20<sup>th</sup> September 2022

**Development Application No. DA2022/0469**  
**Issues response/ Supplementary Statement of Environmental Effects**  
**Construction of shop top housing**  
**1102 Barrenjoey Road, Palm Beach**

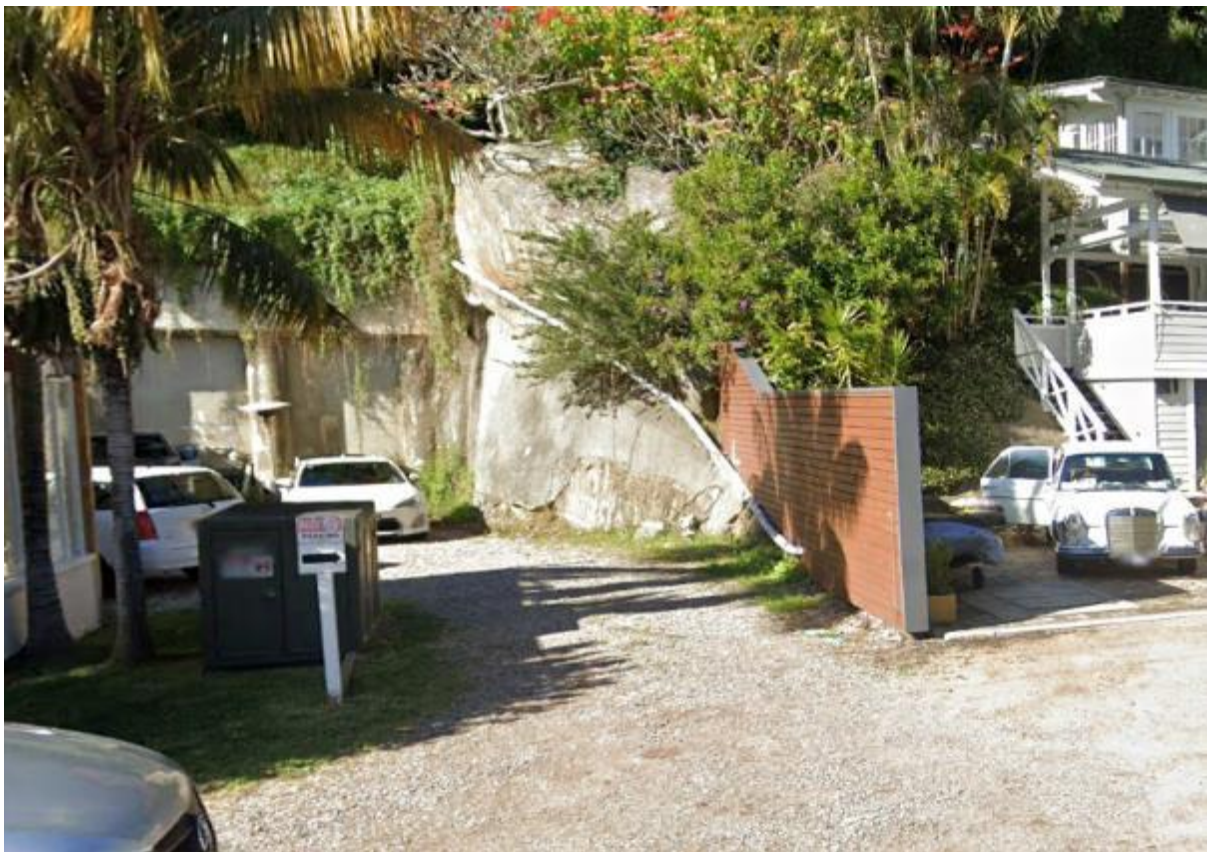
## **Survey detail**

In relation to the interpolation of undisturbed ground levels across the site, assistance has been obtained from survey information in relation to the undisturbed levels along the property boundaries. The photograph at Figure 1 below clearly depicts the extent of excavation which has occurred across the site relative to the undisturbed levels adjacent to the southern and eastern boundaries of the property.

Having undertaken an inspection of the site, and made my own observations, I am satisfied that the interpolated undisturbed 8.5 metre height blanket is generally reflective of the undisturbed levels of the site which would have likely existed prior to any development on the land.

**Figure 2** – Plan extract depicting the spatial relationship of the proposed Level 2 rear facing bedroom windows relative to the recently approved primary and secondary dwellings on the adjoining property to the east No. 1110 Barrenjoey Road (DA2021/0200).

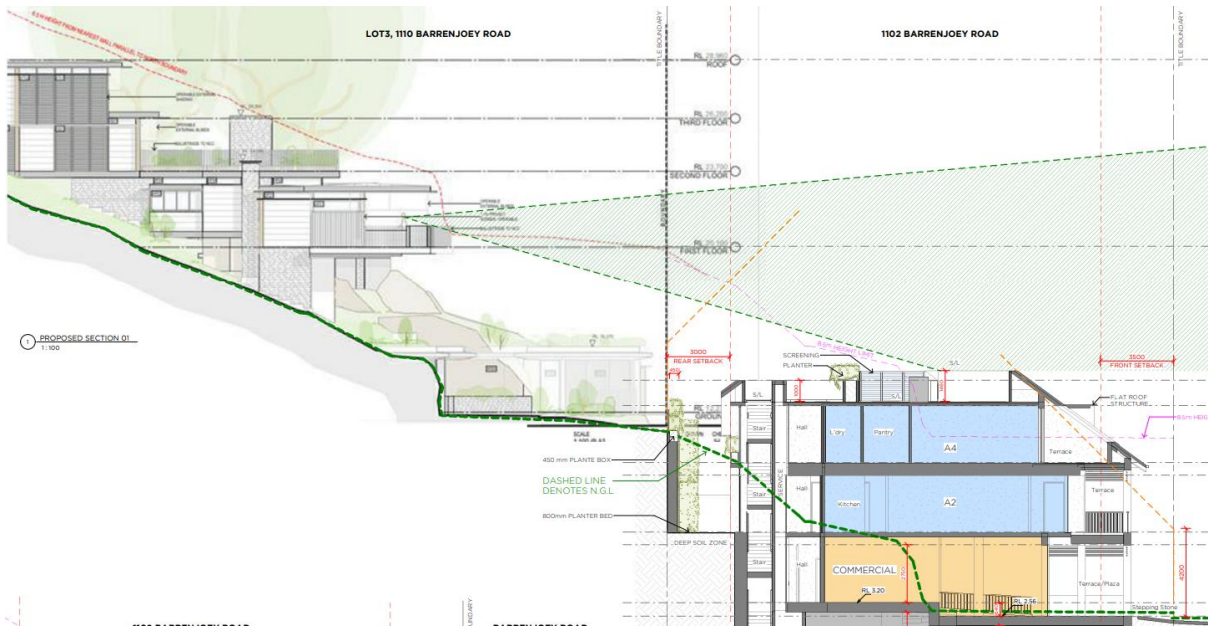
### **Rear boundary treatments and interface**

Response: The sections over page show the spatial relationship of the proposed Level 2 rear facing bedroom windows relative to the recently approved primary and secondary dwellings located on the adjoining property to the east No. 1110 Barrenjoey Road (DA2021/0200).

These diagrams demonstrate that an appropriate level of privacy is maintained between adjoining development due to available view lines and intervening boundary fence and landscape elements with there being an ability for both property owners to supplement the level of privacy through an increase in the height any dividing fence to 1.6 metres. Such fencing would also address any safety concerns in relation to the depth of excavation adjacent to the common boundary.
